ECCS PASSIVE HEAT SINK  
DATA AND INFORMATION

Gilbert Associates, Inc.  
525 Lancaster Avenue  
Reading, Pa. 19603

This report presents the summarized results of a detailed evaluation and calculation performed in response to the United States Nuclear Regulatory Commission (NRC) request for addition information dated August 12, 1975 relative to Crystal River Unit No. 3 Docket No. 50-302 ECCS parameters and comparison to referenced BAW-10103 Topical Report.

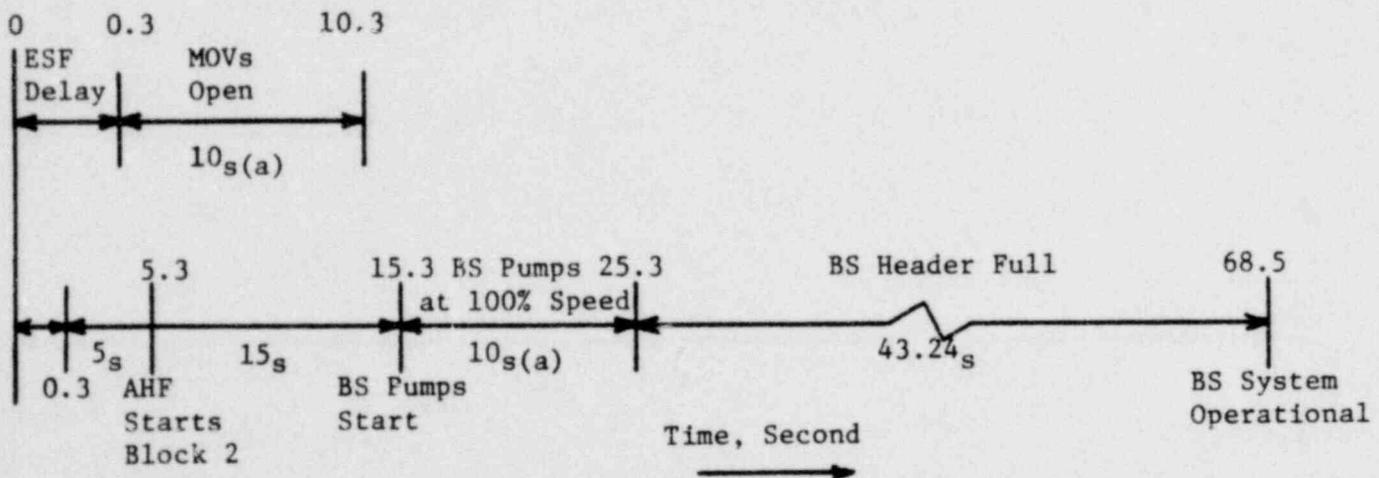
### 2. Air Handling Recirculation and Cooling Units

The only requirement for AHF-1A, 1B, & 1C to be operating in the E. S. mode is that block 2 of the diesel loading sequence has been accomplished. When block 2 is loaded, all three fans will go on low speed operation. Completion of block loading will be 0.3 seconds as in 1 (b) above, and an additional 5

second time delay occurs before block 2 is loaded. An undervoltage condition would have the same effect as described in 1 (b) above.

### Conclusion

Air handling fans will initiate containment cooling in a minimum of 5.3 seconds if normal AC power is available, or 12.5 seconds if diesels are required as compared to BAW-10103 of no delay.

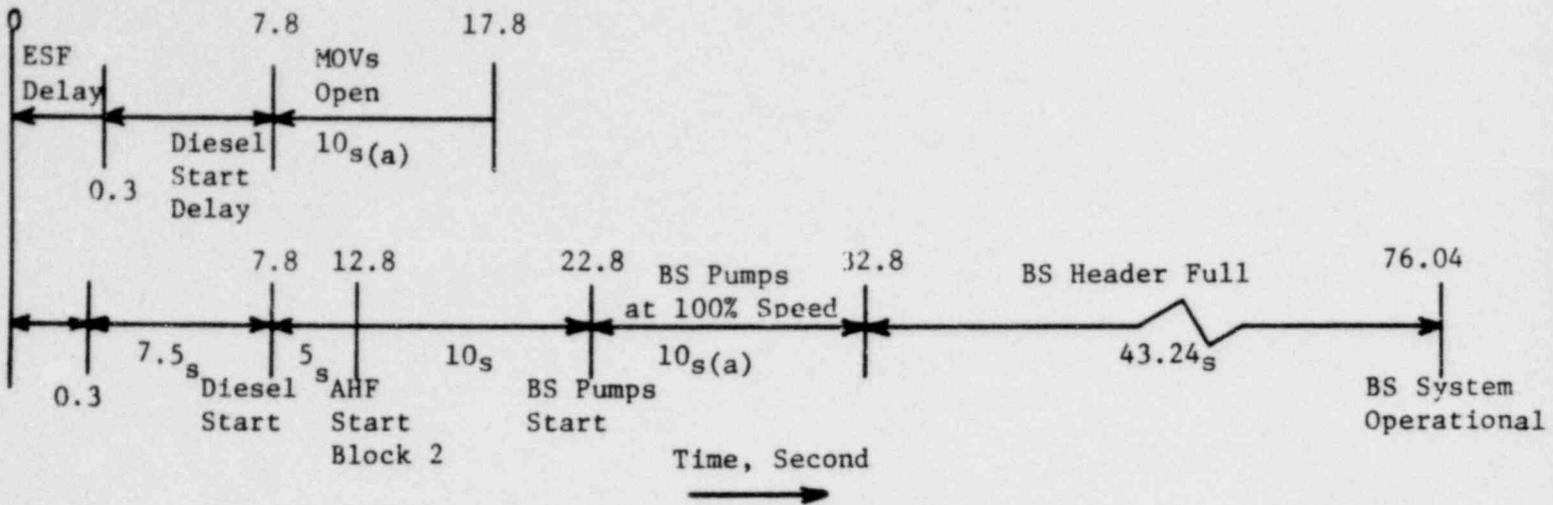
- 2.3 Starting Time of Containment Cooling System(s) - Discuss the factors that show that the start time(s) assumed in the containment response analysis represent the earliest possible initiation of system(s) operation.

A breakdown of the starting time, which yields the quickest activation time for the spray systems is shown below:

(a) Assumed Value (Conservative)

Note: The above illustrated times are in excess of those assumed in the containment response analysis (Ref. BAW-10103).
